TECHNICAL REVIEW – WILDFIRE MANAGEMENT FEATURES

Technical Engineering Review - CEQA/AB 130 Analysis

Riverwalk at Studio City

6 May 2026 (Revised 29 May 2026)

Figure 4 – Building Section (Sheet A-3.2, MVE + Partners)

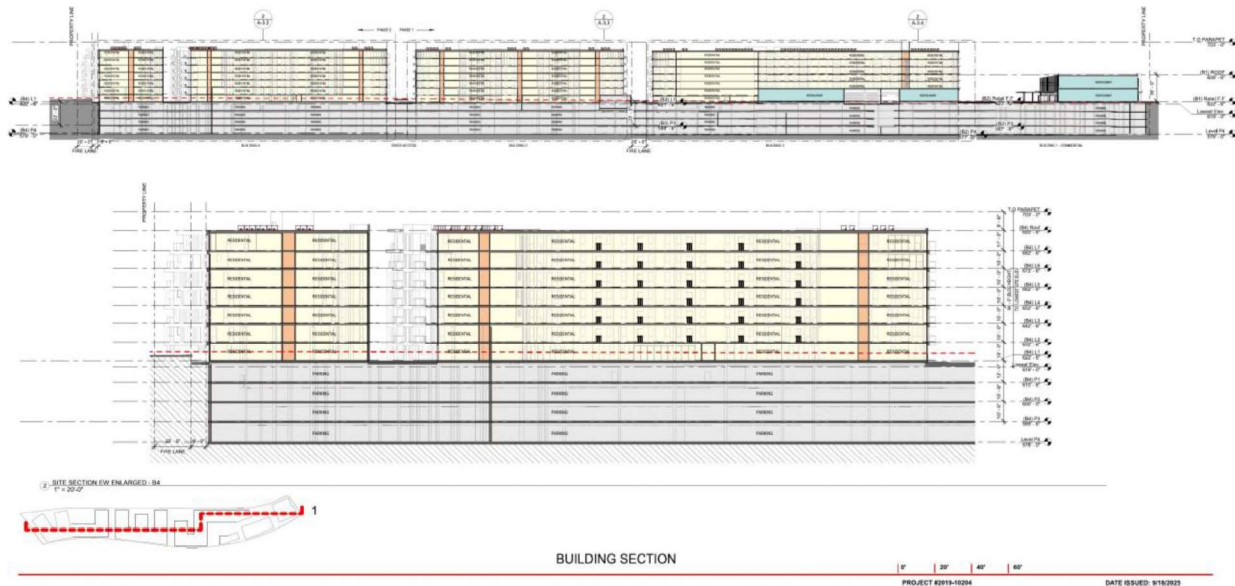
- **Requirement.** Where the vertical distance between the grade plane and the highest roof surface exceeds 30 ft, approved aerial fire apparatus access roads are required (2026 LAFC, Appendix D, Section D105; LAFD comment letter, Appendix C, Exhibits C-1 and C-2). The aerial fire apparatus access road must accommodate the aerial apparatus operating envelope. 2026 LAFC, Section D105.2 establishes a minimum 26 ft unobstructed width at the aerial setup location. The LAFD comment letter establishes a 28 ft minimum width where fire hydrants or aerial apparatus operating positions are located along the access road.

- **Entitlement evidence.** The site plan shows fire lanes at both the western and eastern ends of the site along the Valleyheart Drive frontage and frontage along Ventura Boulevard, an approximately 100 ft wide improved right-of-way (Figure 4). The 20 ft fire lanes shown on the entitlement plans satisfy the general fire apparatus access width per Title 14 CCR Section 1273.01 but do not, on their face, demonstrate the 26 to 28 ft of unobstructed width required at the aerial setup positions. Aerial setup is accommodated within the Ventura Boulevard public right-of-way, an approximately 100 ft improved right-of-way that comfortably exceeds the 26 to 28-ft setup width. For aerial setup positions intended to operate from the Valleyheart Drive frontage, localized widening of the 20 ft on-site fire lanes to 26 to 28 ft at the aerial setup locations will be detailed at the construction document phase.

Figure 4 shows Section through Buildings 2, 3, and 4 with seven-story residential construction over the concrete podium subterranean parking garage, top of parapet at approximately 703 ft, and grade plane at approximately 619 ft (vertical distance approximately 84 ft, exceeding the 30 ft threshold for aerial fire apparatus access under 2026 LAFC, Appendix D, Section D105).

- **CD phase item.** Identify the aerial fire apparatus access road and the aerial setup positions for each of Buildings 2, 3, and 4 on the construction document plot plan submitted to the LAFD Hydrants and Access Unit. Provide a minimum 26 ft unobstructed width at the aerial setup location, increased to 28 ft where fire hydrants or aerial apparatus operating positions are located along the access road. Provide a

load-bearing surface rated for fire apparatus loading per Title 14, CCR Section 1273.01. Document the analysis in Appendix C to this report at the CD phase update.

Figure 5 – Fire Hydrant Location Map
(LADWP IFFAR, signed by Kimberly Haas 29 April 2025)

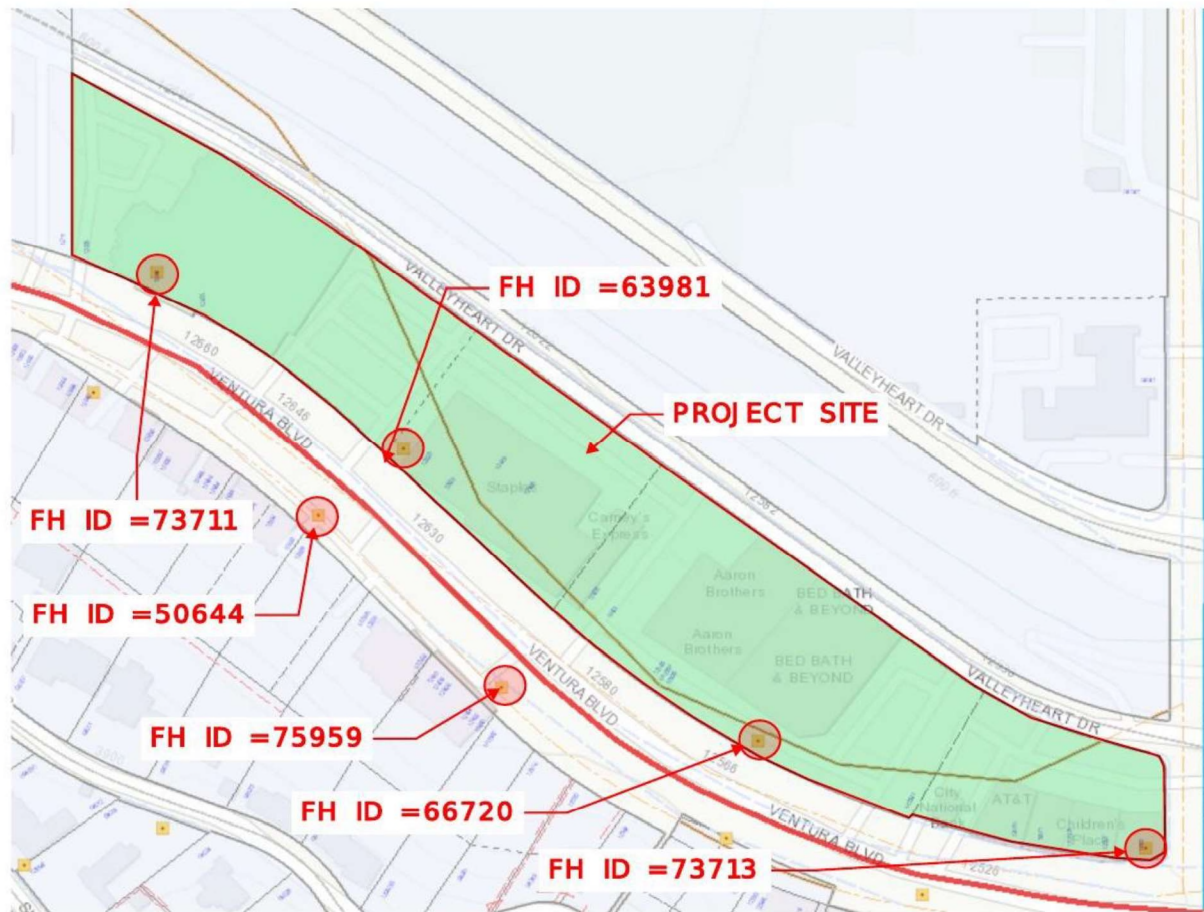
- **Entitlement evidence — LADWP Information of Fire Flow Availability Report.** The site is served by the Los Angeles Department of Water and Power (LADWP) municipal water system. LADWP issued an Information of Fire Flow Availability Report (IFFAR) for the Project, signed by Kimberly Haas, Civil Engineering Associate II, on 29 April 2025 (Figure 5). The IFFAR is provided as Appendix C, Exhibit C-3, and documents the following:

- **CD phase item.** During NFPA 13 sprinkler design-build permitting, the sprinkler engineer of record will perform hydraulic calculations using the IFFAR pressures and verify fire flow adequacy at the FDC and on-site hydrant locations. LAFD Hydrants and Access Unit approval will be obtained through the standard plan check process. The four-hydrant sensitivity scenario annotated on the IFFAR will be confirmed as a robustness check during sprinkler design.
